Staff Report & Recommendation

Historic Preservation Board

DATE: January 8, 2019

HPB18-0248, 1343 Collins Avenue - Clifton Hotel.

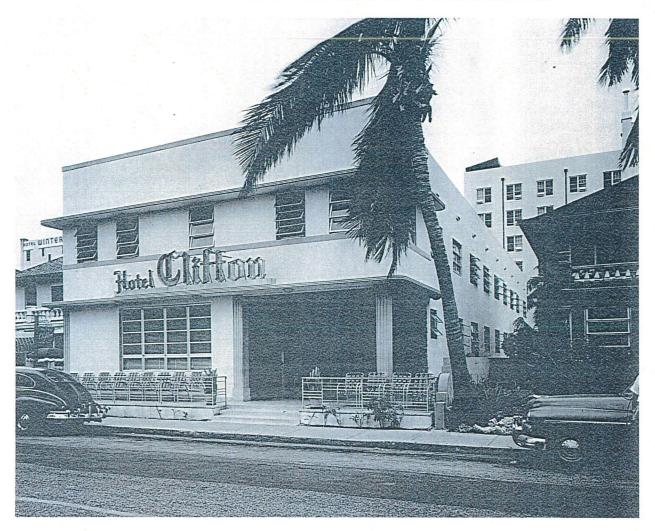
The subject structure, known as the Clifton Hotel, was constructed in 1948 and designed by Gerard Pitt in the Post War Modern Revival style of architecture. No original microfilm plans have been located within the City's Building Department records; however, staff has located a photograph from 1951 (image on following page).
